Mask Set Errata 1

M68HC912D60 Microcontroller Unit

- 1F68K

Figure 1. Representation of Normal start-up condition

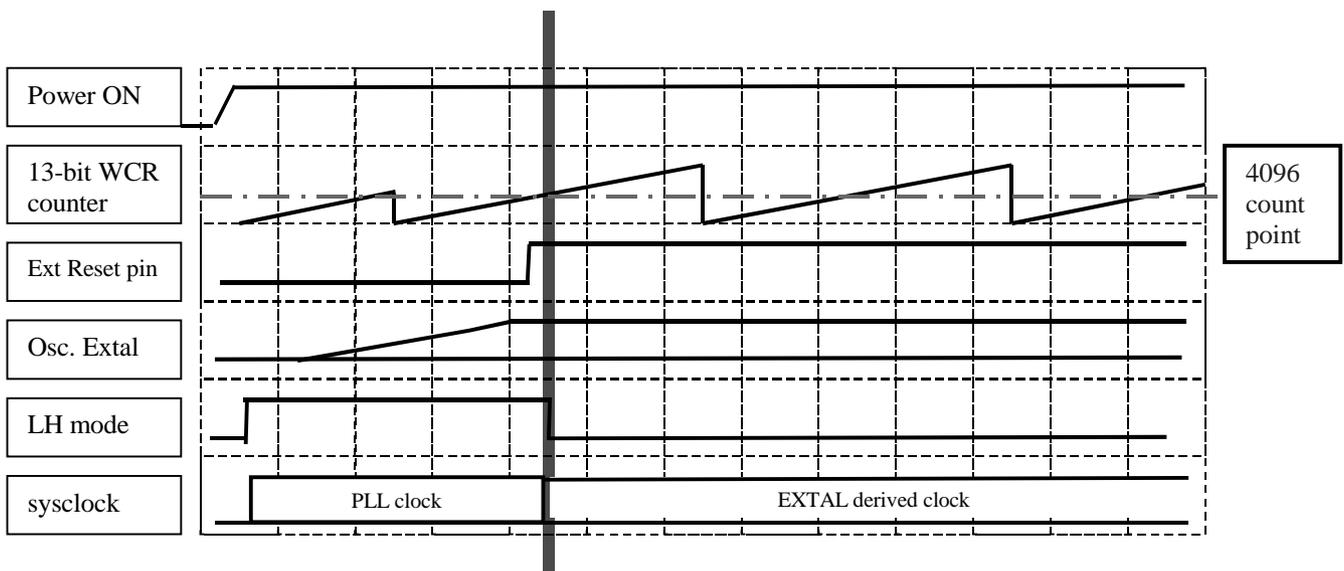
when the WCR (counter register) reaches a count of 4096 cycles, normal operating mode is entered with the CPU clocked from the crystal frequency (see fig. 1).

Figure 2. Representation of unreliable start-up mode with slow crystal

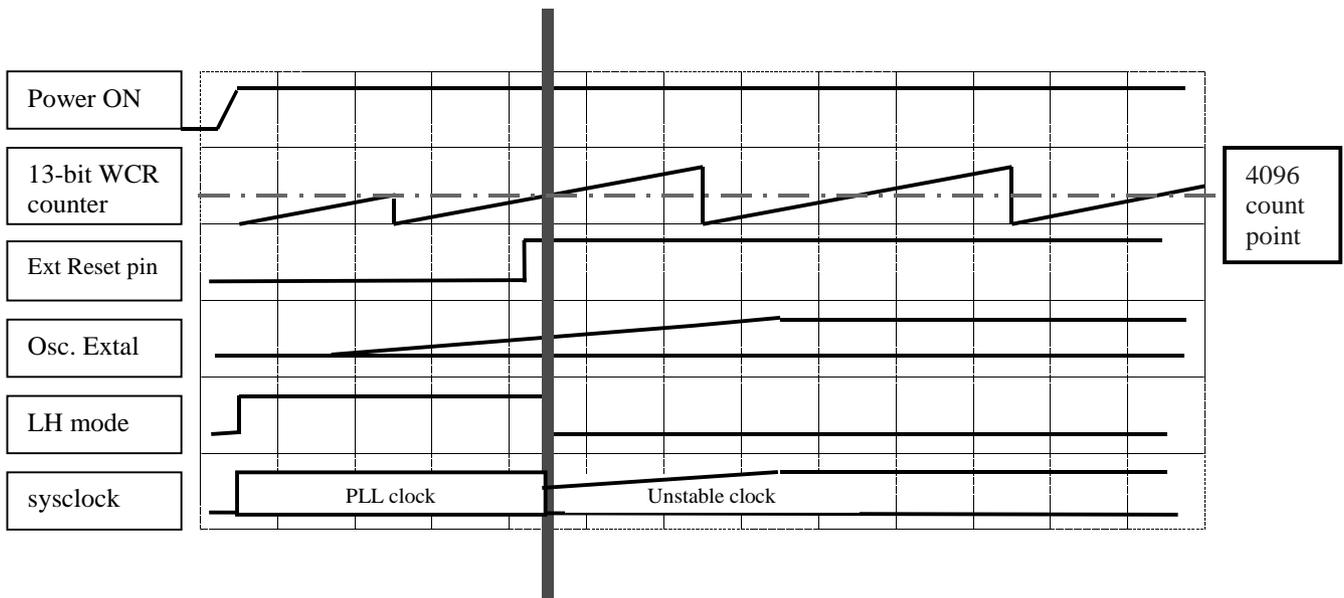
The device can prematurely indicate that the oscillator has stabilized releasing the part from Limp Home clock mode to the oscillator clock mode with an unstable oscillator. This can cause unpredictable behavior of the MCU. This situation can arise with short external power-on reset periods and / or crystal oscillator circuits that exhibit slow startup characteristics. If the PLL is not being used (Vddpll connected to Vss) Limp Home mode is disabled and this issue does not apply.

The HC12 mode of operation known as Limp-Home Mode (LHM) is enabled when the VDDPLL pin is at VDD and is entered if for any reason the external crystal ceases to oscillate. During this mode the CPU will be clocked from the free-running VCO clock of the PLL (at a nominal frequency of 1MHz). If LHM is enabled during the start-up phase (i.e. VDDPLL=5V, NOLHM bit=0) and the external RESET line is not held active until after the crystal frequency is stable then the device starts up in LHM since no crystal oscillations will be detected. This situation can arise with short reset periods and/or crystals that exhibit slow start-up characteristics.

For the first 4096 cycles i.e. during the internal reset period, Limp Home mode will be de-asserted if oscillator activity is detected by the clock monitor circuit -due to the asserted Reset signal there can be no CPU activity during the Reset phase. Following release of the external or internal POR RESET in LHM (which ever is later) the crystal oscillator is sampled by the clock monitor circuit after another 4096 VCO clock cycles and at intervals of 8192 clock cycles thereafter until the crystal is deemed to be operating. If the crystal oscillator is showing activity at the time it is checked then it will be deemed to be good, even though it may not have fully stabilized, and LHM will be de-asserted. This can cause the device to switch from LH mode to normal mode with the CPU clocked from an unstable signal from the crystal oscillator (see fig. 2) resulting in unpredictable function of the CPU.

Figure 3. Representation of preferred means of overcoming issue with Figure 2

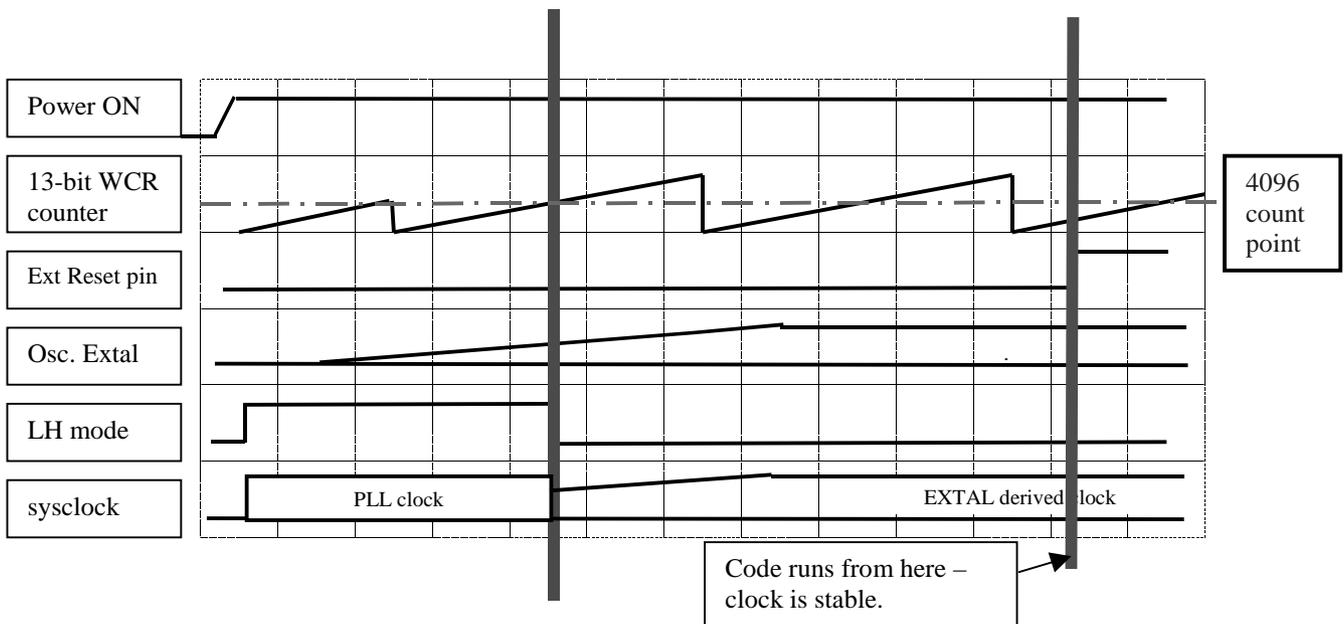
The Reset condition can be overcome by allowing the crystal oscillator circuit to stabilize before releasing the external RESET line (see fig. 3). Operation is similar to that shown in fig 2.

To determine if crystal is 'stable' at the release of reset can be difficult and the time can vary some from board to board. If the customer has special high impedance probes, it is possible to monitor the amplitude of the voltage from XTAL to ground (<2 pF scope probes are recommended). Please note that any loading on the circuit can affect its operation. (Any resistance to ground or Vdd on the EXTAL pin can greatly attenuate the amplifier gain and cause erroneous operation.)

Lastly, an alternative and simpler approach is to just hold reset low for a substantial time (> 100 milliseconds) after Vdd has reached the operating voltage range.
